REMARKS

Serial No. 09/887,092

Attachments: Replacement Sheet and Annotated Sheet for Amended Fig. 6

FIG. 6

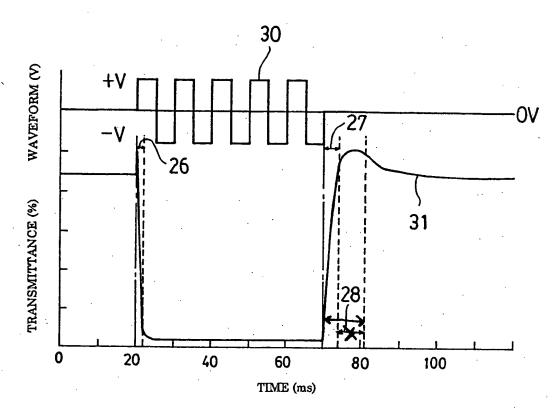
Applicants propose changes for Figure 6 in order to correct the term that the reference numeral 28 indicates. In the PCT international stage of this application, the length of the term, which is indicated by double-headed arrow, of the reference numeral 28 was erroneously traced. It is changed to be traced in the same length as the term of the reference numeral 28 shown in the Fig. 6 of JP8-115897, which is the priority application of the PCT (present) application.

The description on page 18, lines 8-25 of the English specification supports the correction of Fig. 6. In lines 10-11 and 24-25 of page 18, the specification indicates that, "After the elapse of about 10 ms of a holding time 28 ... the scan term Ts is set to be 4 ms which is shorter than the 10 ms of the holding time 28". However, the term indicated by the double-headed arrow of "holding time 28" in present Fig. 6 is much shorter than 10 ms with reference to the time scale on the horizontal axis. If the term is corrected by including "off-response time 27" as shown in the attached copy of the corrected drawing, the term becomes about 10 ms, thereby matching to the aforementioned description.
